PLANNING NMA-CHANGE LIST		
ID	Proposed Changes to plans that are 'Non Material'	Reason for 'Amendment'
A	Changes to Common stair towards compliance for general access where a clear landing needs to be provided and to accommodate smoke control. Circulation area and internal doorway to stairs rearranged to adapt corridor aisle. Stairs, structurally stacked for construction leading towards the corridor or lobby next to the stair being provided with a smoke vent and a store area provision on ground level. Rearrangement in plan due to the above visible on the Northeast facade. Window openings, adapted to suit mentioned changes/rearrangement.	Compliance towards Building Regulations, Part-K-Protection from falling, collision and impact and Part-B-Fire safety
B	Changes to Communal lifts and stairs towards compliance for firefighting where a firefighting shaft is required as the building is over 18m and to accommodate smoke control and building services. Circulation area internal doorway to stairs and clear landing for lifts rearranged to adapt corridor aisle. Stairs, structurally stacked for construction leading towards a vertical smoke shaft that opens at roof level with rationalised comm

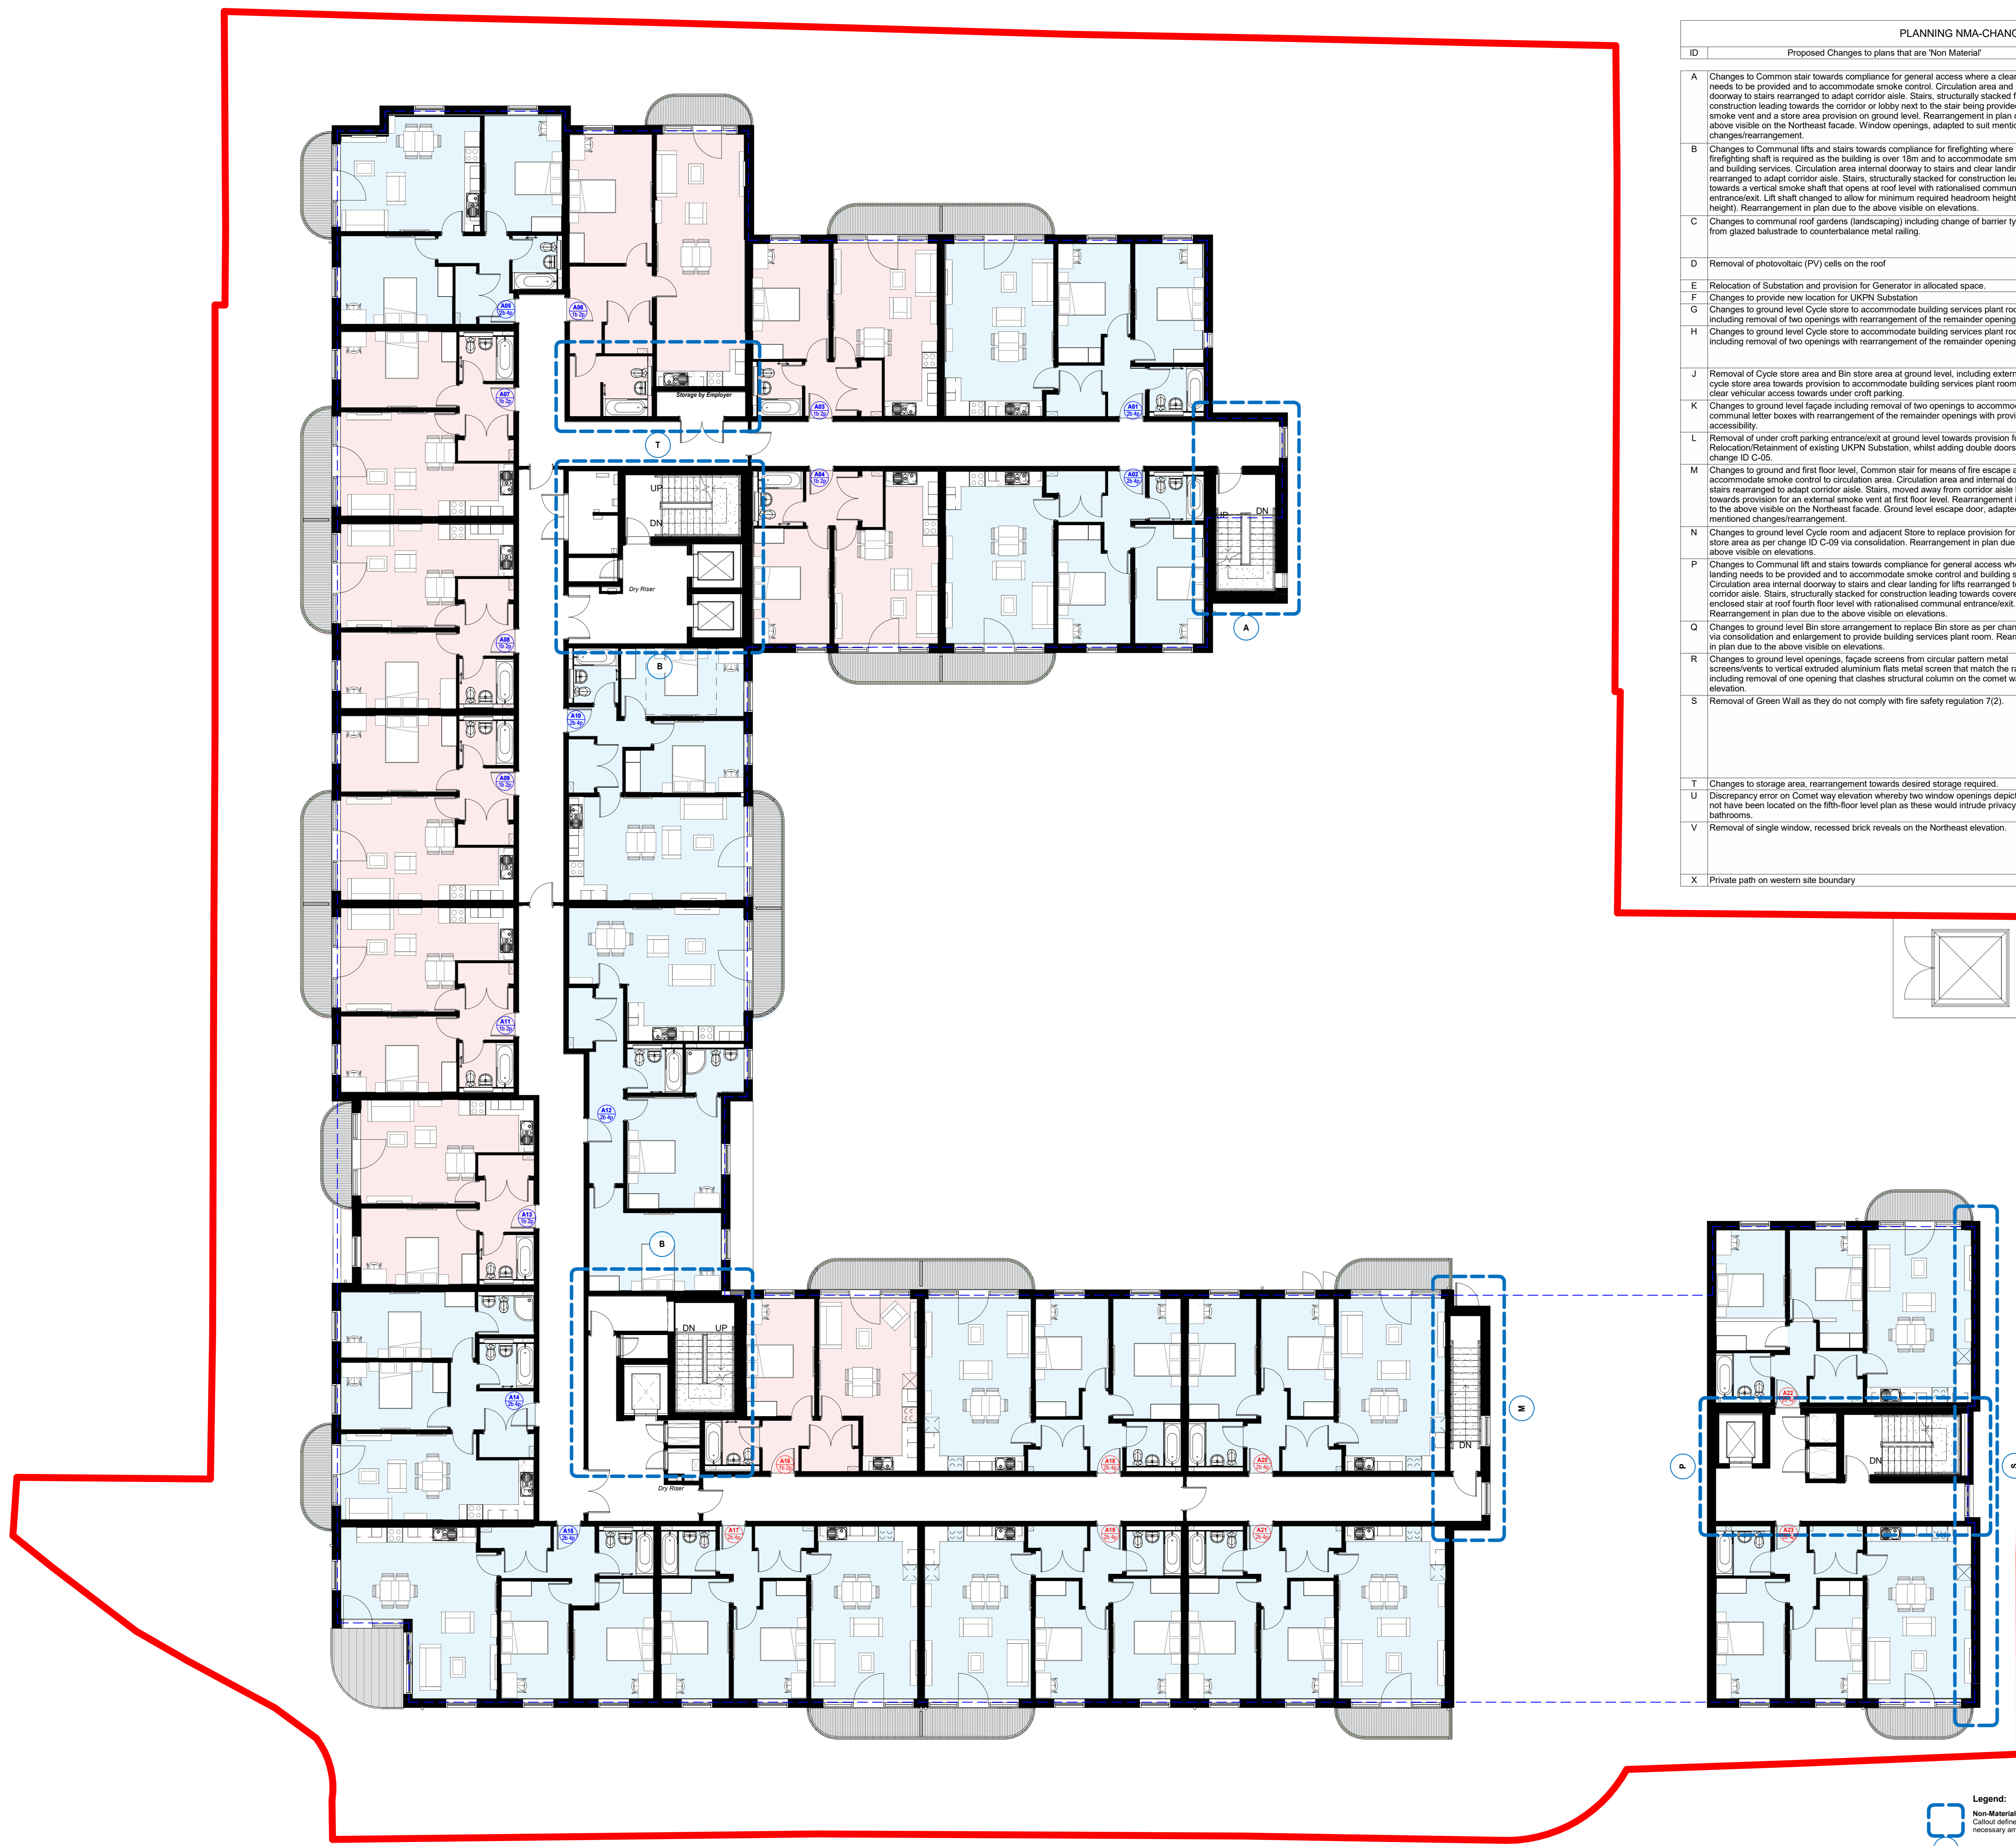
C	Changes to communal roof gardens (landscaping) including change of barrier type (railing) from glazed balustrade to counterbalance metal railing.	To contribute positively towards biodiversity via balance of soft and hard landscaping schemes including provisions for bird and bat boxes, whilst maintaining overall uniformity for railing type
D	Removal of photovoltaic (PV) cells on the roof	PV was not required as Part L requirement was met using Exhaust Air Heat Pumps
E	Relocation of Substation and provision for Generator in allocated space.	Provision for separate secluded area for generator
F	Changes to provide new location for UKPN Substation	Provision for future relocation for UKPN Substation
G	Changes to ground level Cycle store to accommodate building services plant rooms including removal of two openings with rearrangement of the remainder openings.	Provision towards Building Services, Secondary LV switch room and Comms room.

H	Changes to ground level Cycle store to accommodate building services plant rooms including removal of two openings with rearrangement of the remainder openings.	Provision towards secure access and splitting into 4 small bin stores to comply with recent updates of having maximum 8 large (1100lrs) receptacles within.
J	Removal of Cycle store area and Bin store area at ground level, including external door in cycle store area towards provision to accommodate building services plant room including clear vehicular access towards undercroft parking.	Provision towards Building Services, Primary LV switch room and vehicular access towards undercroft parking.
K	Changes to ground level facade including removal of two openings to accommodate communal letter boxes with rearrangement of the remainder openings with provision for accessibility.	Provision towards communal letter boxes
L	Removal of undercroft parking entrance/exit at ground level towards provision for Relocation/Retention of existing UKPN Substation, whilst adding double doors as per change ID C-05.	Provision towards single point of entry/exit for undercroft parking and towards relocation/retention of existing UKPN Substation mentioned in change ID-E.

M	Changes to ground and first floor level, Common stair for means of fire escape and to accommodate smoke control to circulation area. Circulation area and internal doorway to stairs rearranged to adapt corridor aisle. Stairs, moved away from corridor aisle leading towards provision for an external smoke vent at first floor level. Rearrangement in plan due to the above visible on the Northeast facade. Ground level escape door, adapted to suit mentioned changes/rearrangement.	Compliance towards Building Regulations, Part-B-Fire safety.
N	Changes to ground level Cycle room and adjacent Store to replace provision for Cycle store area as per change ID C-09 via consolidation. Rearrangement in plan due to the above visible on elevations.	Provision towards replacement of removed cycle store mentioned in change ID-J.
P	Changes to Communal lift and stairs towards compliance for general access where a clear landing needs to be provided and to accommodate smoke control and building services. Circulation area internal doorway to stairs and clear landing for lifts rearranged to adapt corridor aisle. Stairs, structurally stacked for construction leading towards covered and enclosed stair at roof fourth floor level with rationalised communal entrance/exit. Rearrangement in plan due to the above visible on elevations.	Compliance towards Building Regulations, Part-K-Protection from falling, collision and impact, Part-B-Fire safety and Provision for stair enclosed/walkway that is directly covered.

Q	Changes to ground level Bin store arrangement to replace Bin store as per change ID C-09 via consolidation and enlargement to provide building services plant room. Rearrangement in plan due to the above visible on elevations.	Provision towards replacement of removed Bin store mentioned in change ID-J and provision for BCW Tank room
R	Changes to ground level openings, facade screens from circular pattern metal screens/vents to vertical extruded aluminium flats metal screen that match the railing type, including removal of one opening that clashes structural column on the corner way elevation.	To maintaining overall architectural uniformity and structural framing.
S	Removal of Green Wall as they do not comply with fire safety regulation 7(2).	Regulation 7(2), requires all residential blocks with top storey heights over 18m to have all materials which become part of an external wall or specified attachment (e.g., balconies) to achieve class A2-s1, d0 or class A1, except for materials which are exempt as per regulation 7(3). Additionally, membranes used as part of external wall construction above ground should achieve a minimum of class B-s3, d0.

T	Changes to storage area, rearrangement towards desired storage required.	Provision towards desired storage required.
U	Discrepancy error on Comet way elevation whereby two window openings depicted would not have been located on the fifth-floor level plan as these would intrude privacy for the bathrooms.	Discrepancy error
V	Removal of single window, recessed brick reveals on the Northeast elevation.	The recessed brick reveals is towards the left of a single pane window for levels 1-4, whilst it changes to a double pane for level 5. To maintain architectural uniformity, we have detailed a constant double pane window for all levels.
X	Private path on western site boundary	For Façade maintenance MEWP access.
